Re: Class II Permissive Change Application for SimpliSafe, FCC ID: U9K-WS3000

This change represents: Changed passive components in antenna matching network

Old Matching Network	New Matching Network

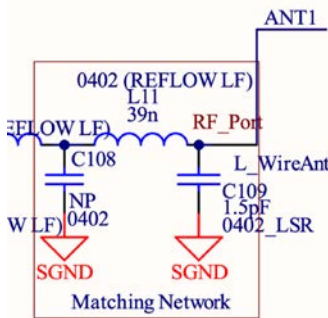
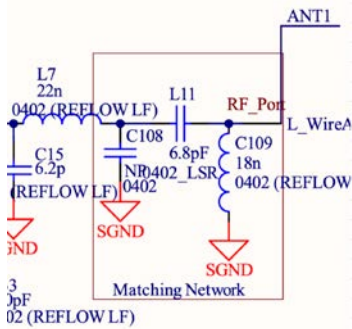
Board Designation	Old Value	New Value
L11	39nH / 0pF	0nH / 6.8pF
C109	1.5pF / 0nH	0pF / 18nH
